Subject: Submittal of Topical Report HI-2200750 "-A" Version

TOPICAL REPORT FOR SPENT FUEL POOL HEAT UP CALCULATION METHODOLOGY

Holtec Project 3131
Holtec Report No. HI-2200750

Subject: Response to Request for Additional Information - Holtec Spent Fuel Pool Heat Up Calculation Methodology Topical Report

Figure 2-1: Radiative coefficient for a square array, Figure 3.6-5 in [2.2]

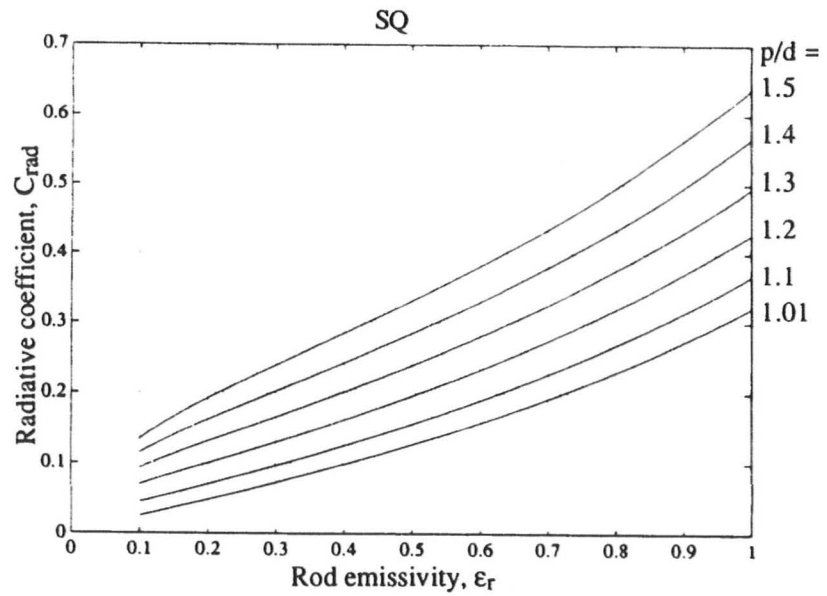
<p style="text-align: center;">Lumped Analysis vs. Pin by Pin Analysis</p> <p>[</p> <p style="text-align: right;">] 4.a, 4.b</p>					
Regulatory Justification	SRP Section 15.0.2, Subsection III.3b				
Associated Section	3.3.1.4 Level of Detail in the Model				
Level of Concern	1	Level of Impact	3	Level of Effort	1
Overall Significance	High				
Holtec Response	<p>[</p> <p style="text-align: right;">] 4.a, 4.b</p> <p>For that, the methodology is expanded as follows:</p> <p>[</p>

[
